Access Compliance Report

Public Rights-of-Way

| Intersection ID: 8861 | Main Street: MELLOW_DR | Cross Street: N_TRYON_ST | Location: NE |
| ADA ID: BA1254BBF726 | Ramp Type: Directional1 | Initial Pass/Fail: Pass | Overall Compliance: No |

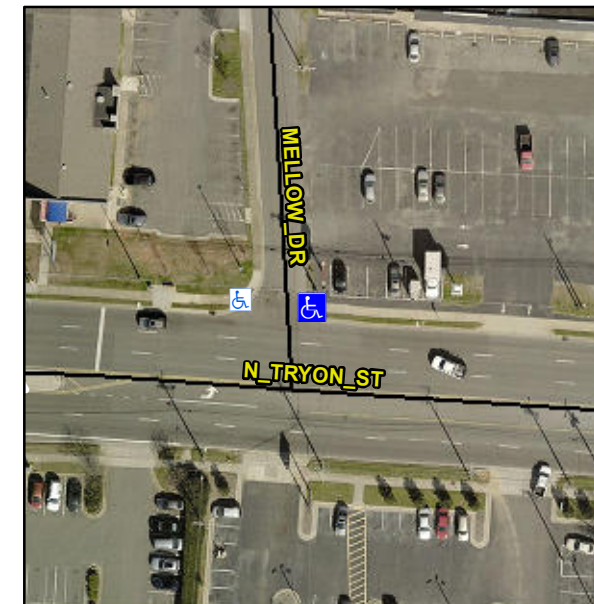
Not Found, R304.2.2-Perp, R304.3.2-Para, R304.5.3, R305.1.4, R305.2, R302.7, R302.7.2

| Compliance | Description | Data | Compliance | Description | Data |
|------------|-----------------------|------|------------|-----------------------------|------|
| Yes | Ramp Width (in) | 59.5 | No | Grade Break Slope (%) | 7.6 |
| Yes | Ramp Slope (%) | 7.3 | No | Grade Break XSlope (%) | 3.6 |
| No | Landing Slope (%) | 4.5 | Yes | DWS Length (in) | 24.0 |
| Yes | Landing X Slope (%) | 0.9 | No | DWS Full Width? | No |
| No | Gutter Ponding? | Yes | Yes | Gutter Slope (%) | 5.0 |
| No | Gutter Lip Ht (in) | 0.5 | Yes | Gutter X Slope (%) | 2.0 |

Remove & Replace Entire Ramp.
